Technical Note

Project Mayfield 2020 Appointment
Subject Hydraulic Modelling – Mayfield Park Phase 1 Full Build Out
Project no 0046688
Date 20 April 2021

Revision	Description	Issued by	Date	Approved (signature)
00	Issue to Environment Agency	HM	22/01/2021	JF
01	Update following Environment Agency review	HM	24/02/2021	JF
02	Update following EA review of Condition 66 details	JF	20/04/2021	CB

Figure 3-1: Representation of proposed channel interventions within hydraulic model

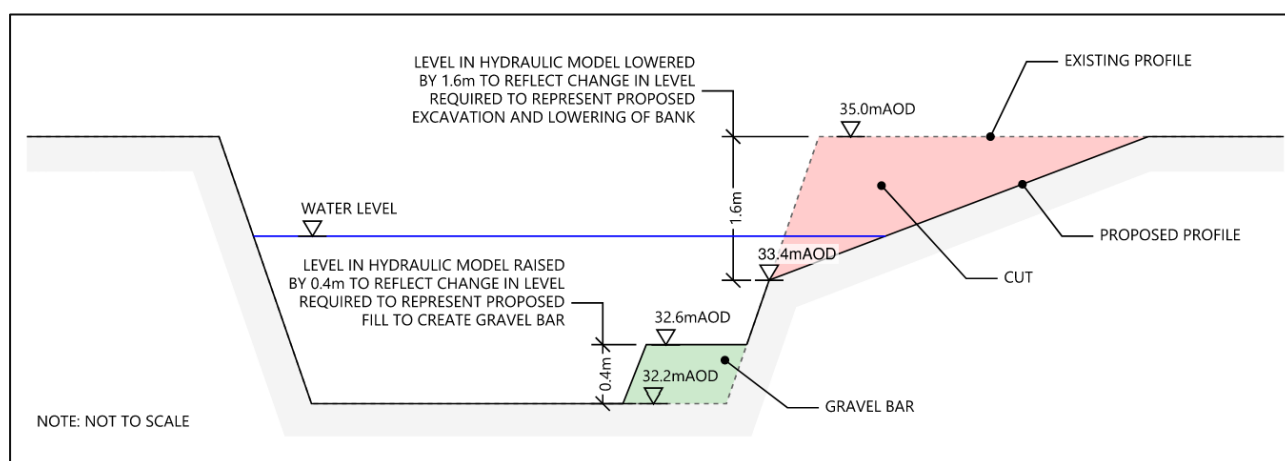
With regards to the channel and bridge geometry, in order to be clear and ease my review, please add detail of how the elevations have been calculated including figures of channel/structure design within the reporting itself.

Therefore, in order to determine the impact of the proposed interventions on flood levels and extent, the cross-sectional profiles of the Full Build Out model have been altered to reflect the *change* in level between the 2020 surveyed levels and the proposed interventions. This approach can be summarised as follows and is shown diagrammatically in Figure 3-1.

Change in level within hydraulic model = Proposed cross-sectional profile – existing cross-sectional profile (2020 survey)

Figure 3-4: Bank heights and baseline water level at the Wildscape area at timestep 00:10, before the main event hydrograph begins

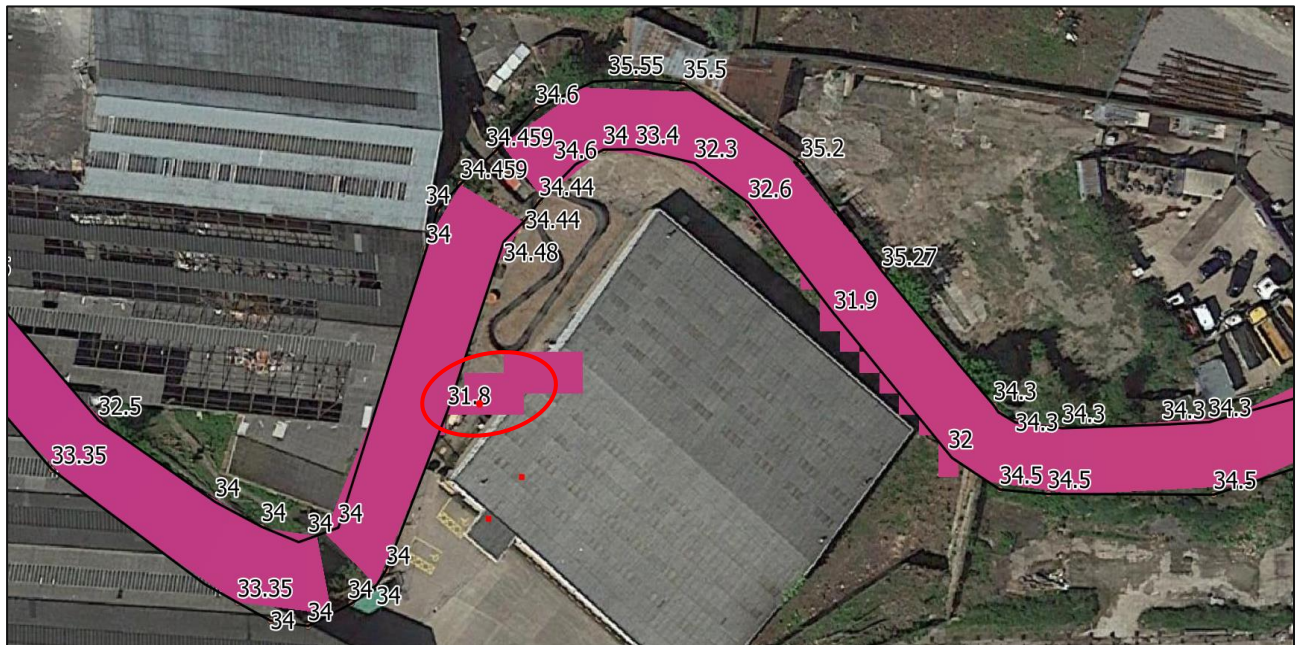
In the version of the Full Build Out model submitted along with Rev. 00 of this report (model no. 192), the mass error peaked at approximately -2.5%. It was identified that the accumulation of mass error occurred between the hours of 0 and 2, when flow in the river is low, and in-channel water levels are very similar to the low point of the left bank adjacent to the Wildscape area, circled in red in Figure 3-4. This causes constant flux between the 1D and the 2D domains, with no clear dominant flow direction. It is concluded that this flux is the cause of the peak in mass error.

In order to prevent the constant movement between 1D and 2D domain during low flow state (hours 0 to 2), the bank height was raised from 31.8mAOD to 32mAOD within the 2D domain, at the inflow point from channel to Wildscape area (circled in red), to match proposed level for low point of Wildscape area.

This amendment is considered a more accurate representation of the proposed scheme, rather than a design change, and does not have an impact on water levels elsewhere within the model.

Figure 3-5: Plots of cumulative mass error against time for the 25 year, 100 year and 100 year + 35% CC events, showing relative performance of the amended Full Build Out model (197) compared to the BHE Baseline 2020 model (142) and the previous Full Build Out model (192)

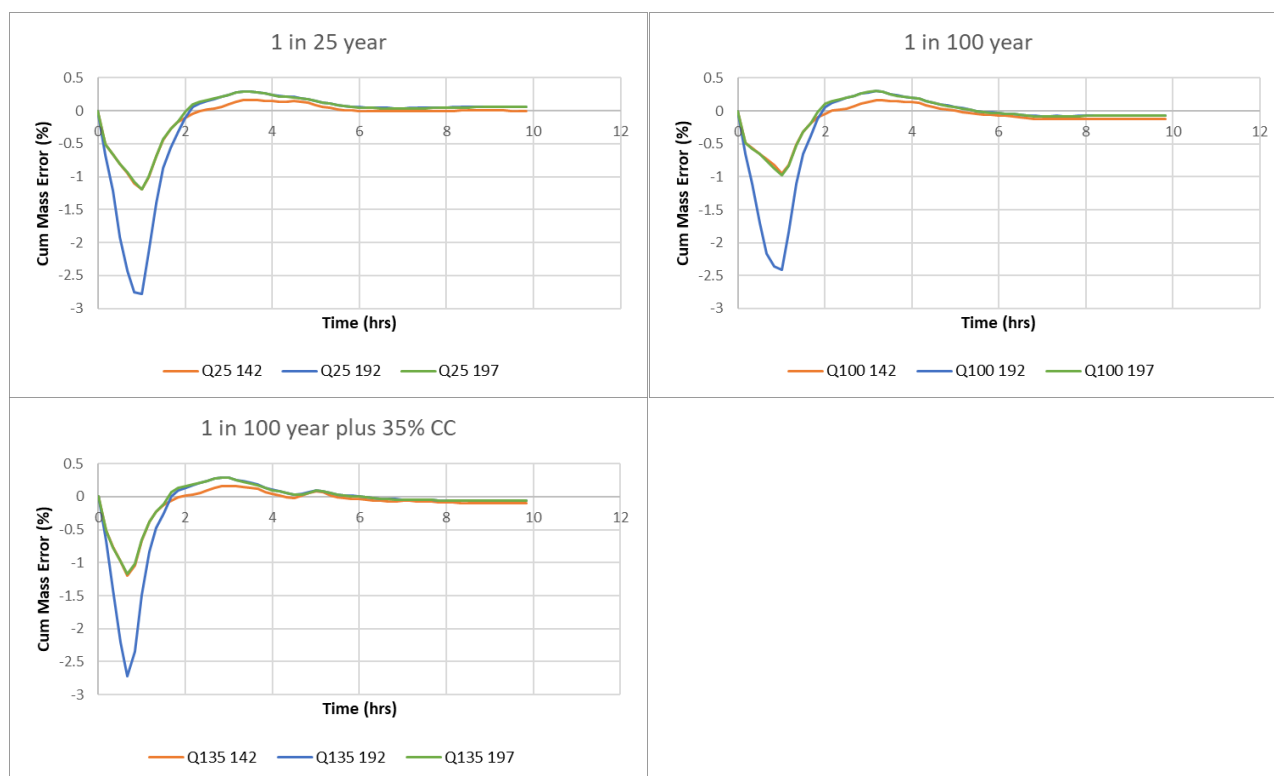
- **The 1D channel cross sections and structures do not appear to match the plans provided.**
- **2D mass balance error is out of tolerance (+/-1%) indicating model instability. This should be reviewed and improved.**

Figure 3-5 provides a graphical comparison of the performance of the amended Full Build Out model (197) against the BHE Baseline 2020 model (142) and the previous iteration of the Full Build Out model (192) for each of the return periods tested.

I'm happy with the approach you've undertaken to reduce the mass balance error and now that it is in line with the Baseline values, this is acceptable. Please go ahead and update the reporting to reflect this change.

Figure 1: Baseline water level at the Wildscape area, annotated with location of cause of mass error

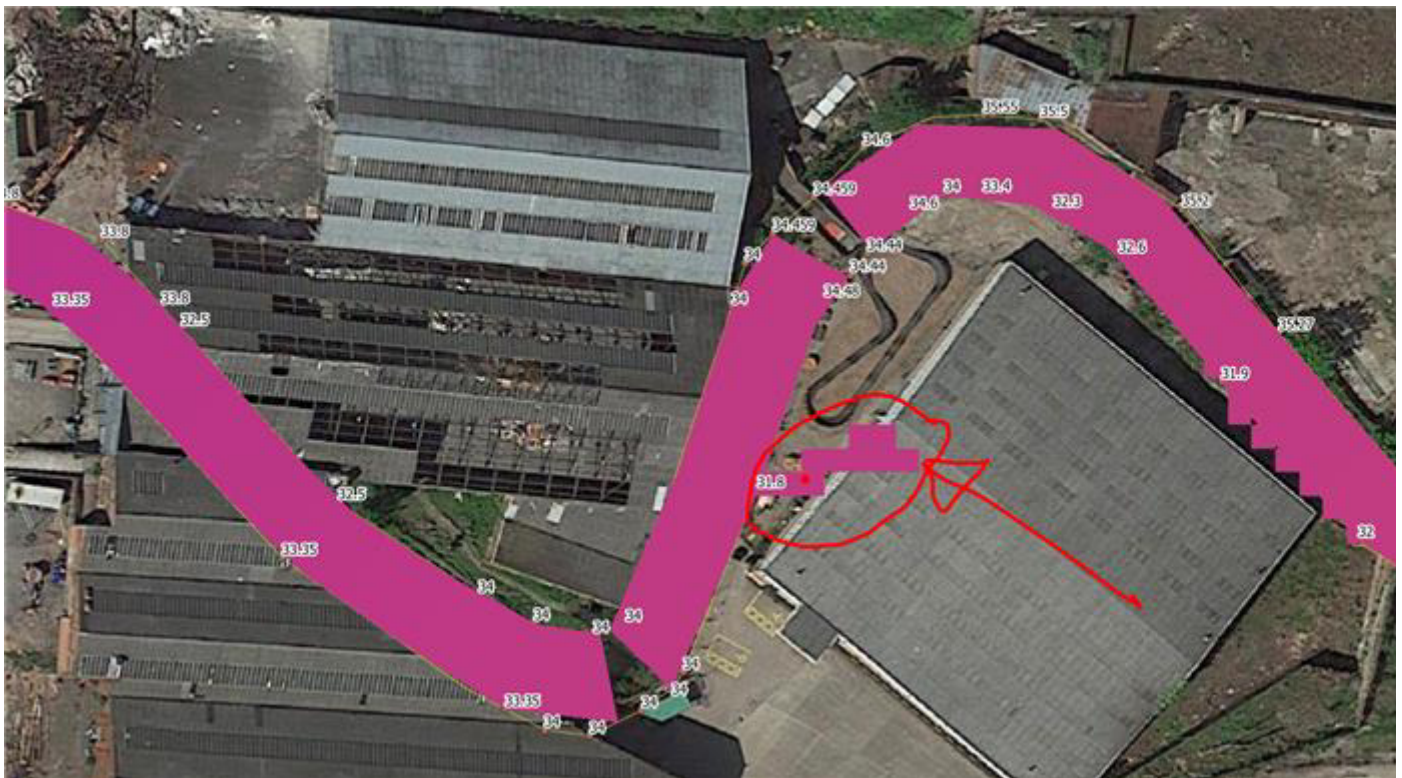
- Accumulation of mass error occurs between the hours of 0 and 2, when flow in the river is low, and in-channel water levels are very similar to the low point of the bank;
- This causes constant flux between the 1D and the 2D domains at the part of the Wildscape area circled in the image in Figure 1, with no clear dominant flow direction;
- Concluded that this flux is the cause of the peak in mass error, as cumulative mass error begins to reduce as water levels increase (Figure. 2).

- Raise bank height from 31.8mAOD to 32mAOD locally, at inflow point from channel to Wildscape area, to match proposed level for low point of Wildscape area
- This prevents movement between 1D and 2D domain during low flow state (hours 0 to 2) and significantly reduces the mass error (Table 1 and Figure 3)
- This amendment is considered a more accurate representation of the proposed scheme, rather than a design change, and does not have an impact on water levels elsewhere within the model
